Septic Tank - Soil Absorption System Construction Permit

Health Department ID Number: 105-04-0075

Location Information		2341 Mount Pleasant Road	
Subdivision Name:		Tax Map:	82(2)8
Property Address:	State Route 602	GPIN:	
County:	Appomattox County	Legal Description:	Section Block Lot
Directions:	460E to prospect, L 626, L 602, .5 mi drive on R gate (farm), 400 yds to site

General Information	
System Type: Type of Property: Residential Conditions: disconnecting existing mh and connecting 2 bedroom block dwelling to existing system	Number of Bedrooms: 2 Daily Flow: 300 gallons

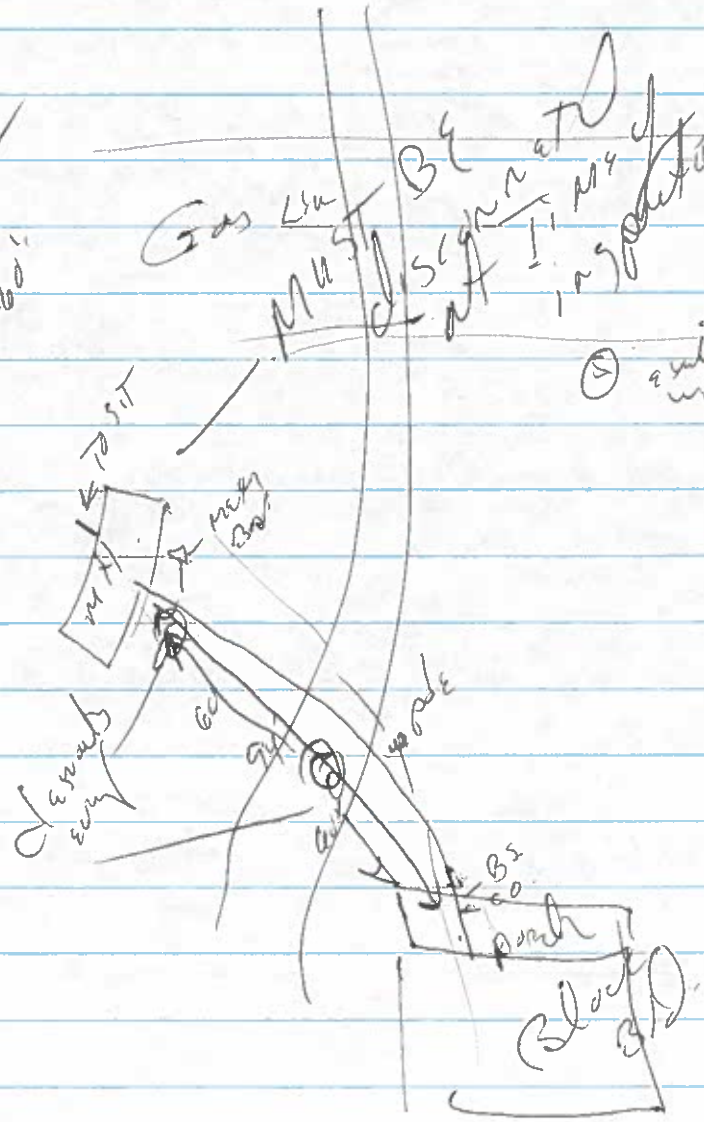
4" to 3" NOT acceptable must BE 4" all the way to 3" all the way clean outs every 50-60"

Gas Line MUST BE disconnected at time of inspection

Bring clean out to surface.
